<p>CARNEGIE FORUM 305 WEST PINE STREET LODI, CALIFORNIA</p>	<p style="text-align: center;">AGENDA LODI SITE PLAN & ARCHITECTURAL REVIEW COMMITTEE</p>	<p style="text-align: center;"><u>REGULAR SESSION</u> WEDNESDAY, FEBRUARY 9, 2011 @ 5:15 PM</p>
---	--	--

To: Site Plan and Architectural Review Committee
From: Immanuel Bereket, Associate Planner, Community Development Department
Date: February 9, 2011
Subject: Request for Site Plan and Architecture Review Committee to permit façade remodel to an existing vacant commercial building, construction of two buildings and related site improvements at 37 South Sacramento Street (Applicant, Aster Canet; File # 11-SP-01).

To: Site Plan and Architectural Review Committee
From: Immanuel Bereket, Associate Planner, Community Development Department
Date: February 9, 2011
Subject: Request that the Site Plan and Architectural Review Committee review and approve an application to remodel and expand an existing A&W restaurant at 216 East Lodi Avenue. (Applicant, Peter Knight; File # 10-SP-11).

SITE PLAN

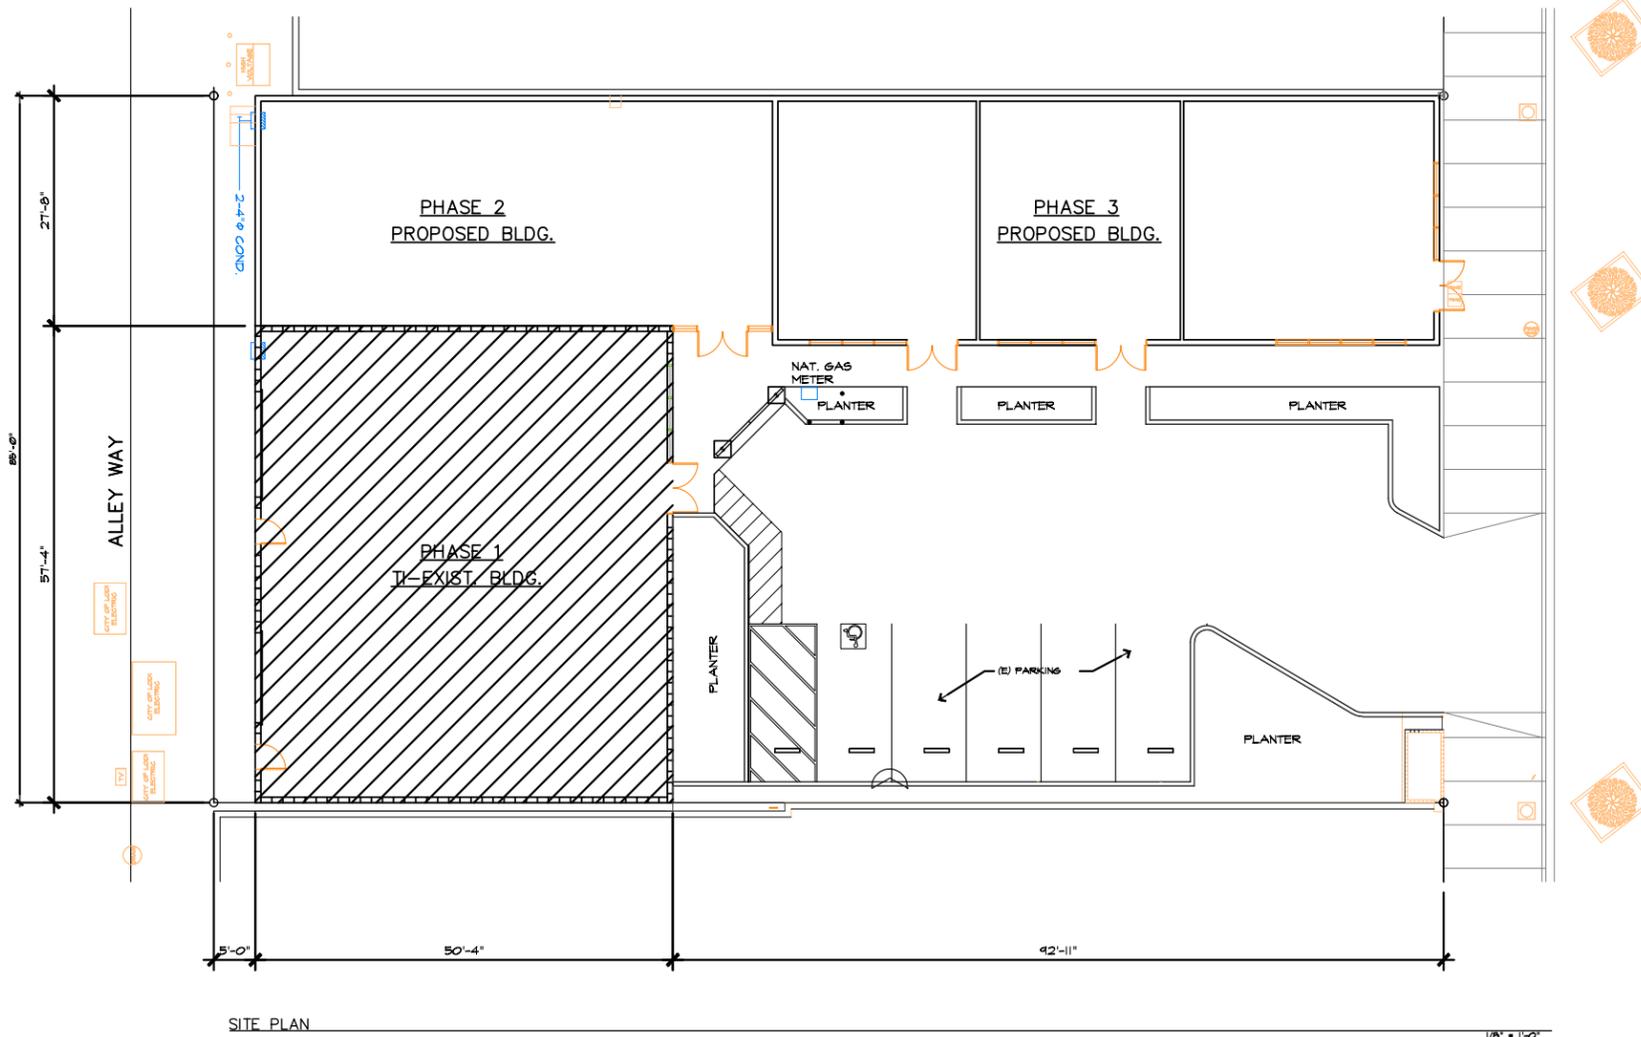
17. The site plan provided shows new buildings to be constructed in Phase 2 and Phase 3. These buildings appear to be additions to the existing building. As the square footage is increased by more than 50% of the original building and exceeds 6000 sqft, the new and existing buildings will be required to be equipped with fire sprinklers, as per LMC 15.20.160. The Municipal Code specifically excludes the use of area separation walls (fire walls as described by 2011 CBC, Section 706) as an exception. The Municipal Code section is included for your convenience. Plans shall include a fire control room for the installation of a fire sprinkler system.

20. Phase 3 building shows the door entrance opening into the public right of way. The door entrance must recess into the building or be relocated such that the doors do not open into the public right of way.
21. All project design and construction shall be in compliance with the Americans with Disabilities Act (ADA). Project compliance with ADA standards is the developer's responsibility.
22. Payment of the following prior to building permit issuance unless noted otherwise:
 - a. Filing and processing fees and charges for services performed by City forces per the Public Works Fee and Service Charge Schedule.
 - b. Wastewater Capacity Impact Fee at the time of occupancy.
 - c. County Facilities Fees at the time of building permit issuance.
 - d. Regional Transportation Impact Fee (RTIF) at the time of building permit issuance.

LANDSCAPE PLAN

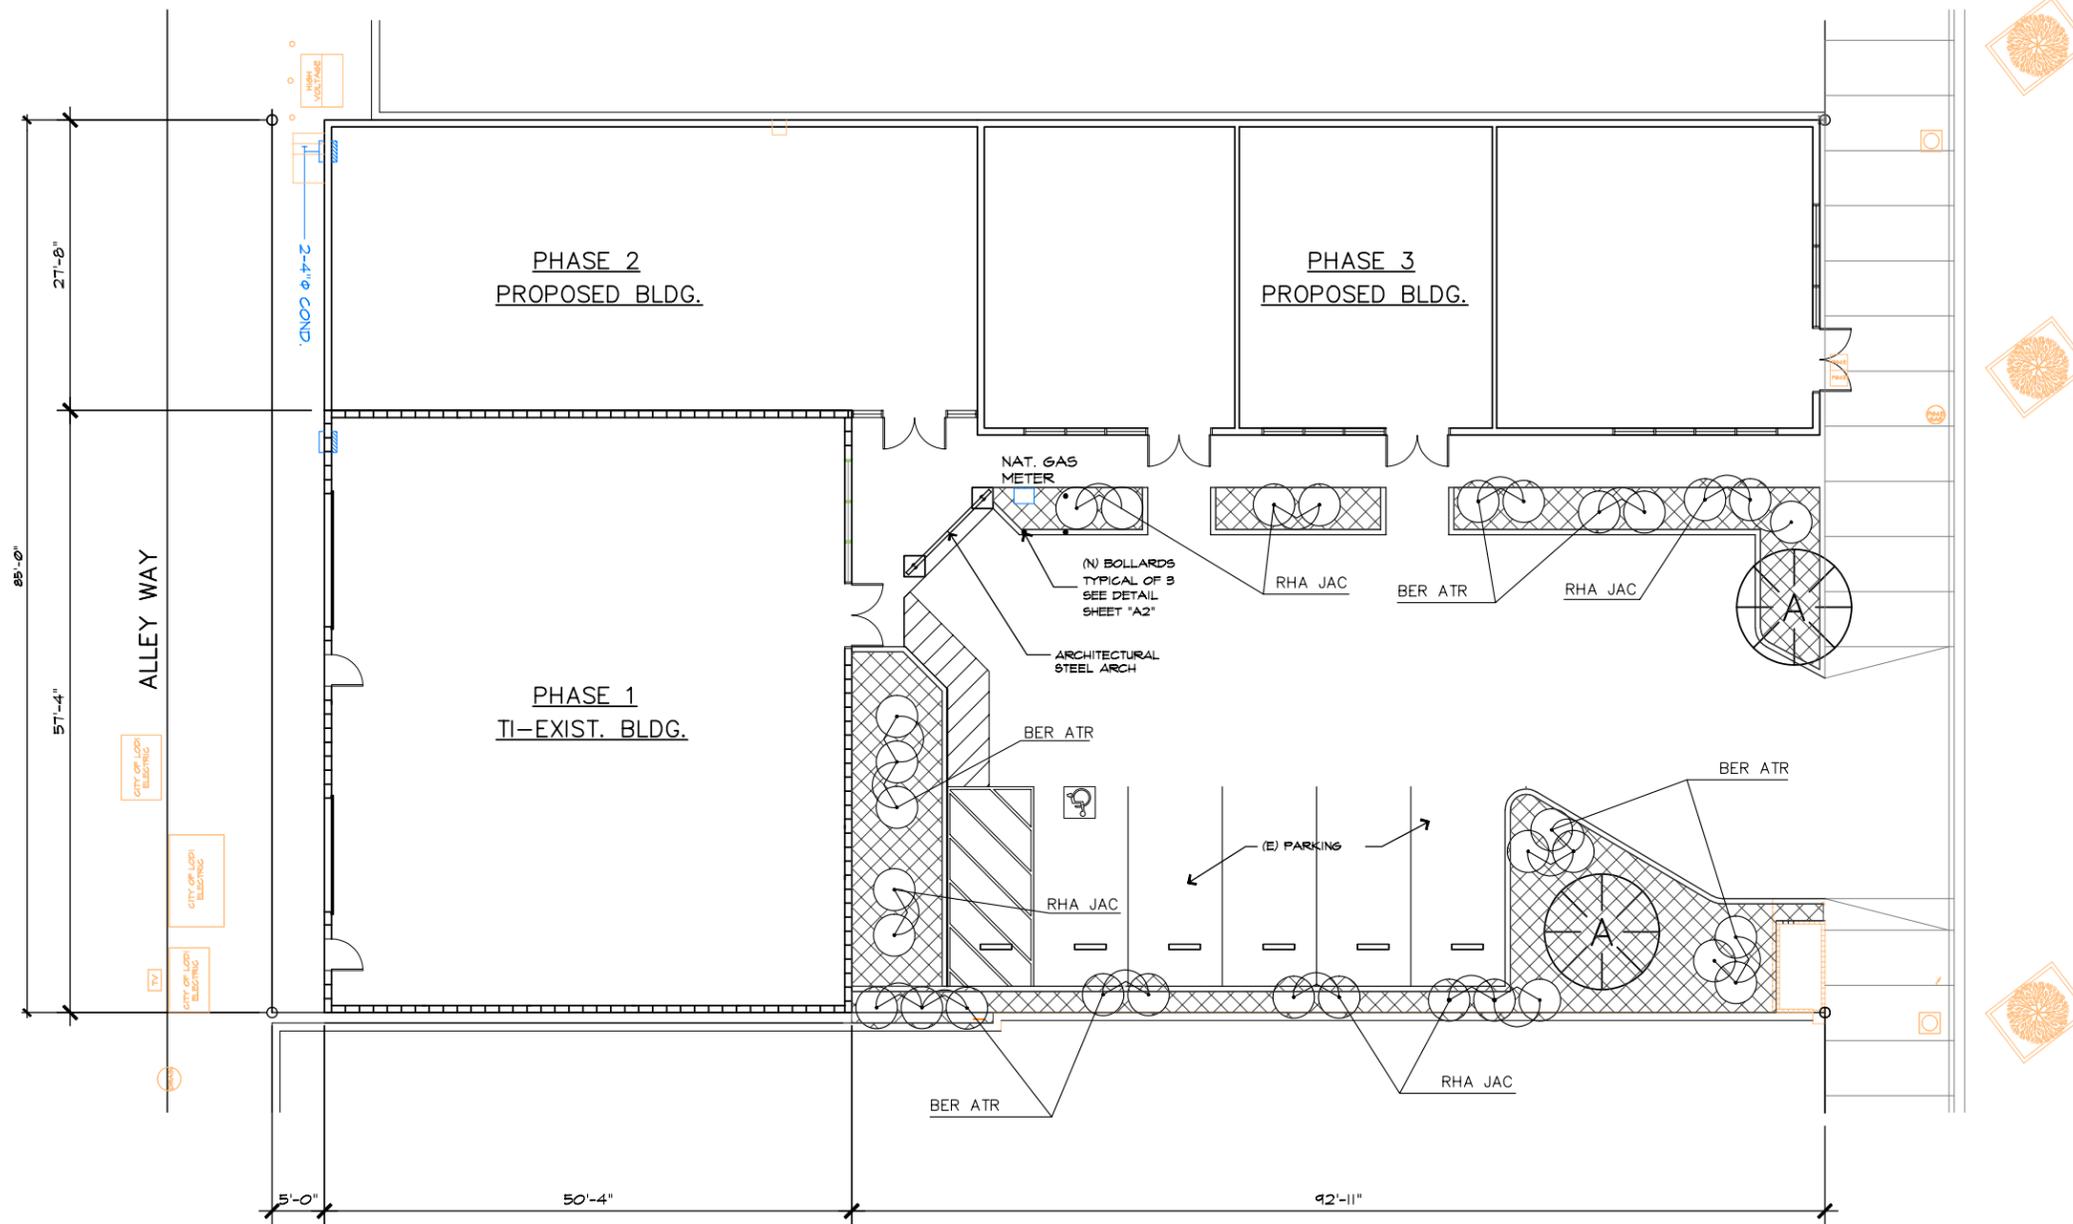
Given that the site is within downtown, staff recommends the proposed refuse enclosure must maintain at least a 10-ft setback from Sacramento Street and must be provided, at the very least, with trellis type cover. Further, landscaping plan should encourage creeping vines, or other similar plant specie, to grow over the refuse walls so as to discourage graffiti. The proposed landscape plan illustrates landscaping along the southern property line, planter islands in front of the buildings and on the entry ways. The proposed landscape plan calls for shrubs, trees. Staff has reviewed the proposed landscape plan and determined that it complies with the requirements of the City's landscape requirements.

11. The applicant shall add a trellis over the trash enclosure. The landscaping plan shall encourage vines to grow over the trash enclosure trellis.
12. All signs shall comply with the City of Lodi's Zoning Ordinances. All signage shall be subject to review and approval of the Community Development Director. All signage shall be individual channel letters or the equivalent.
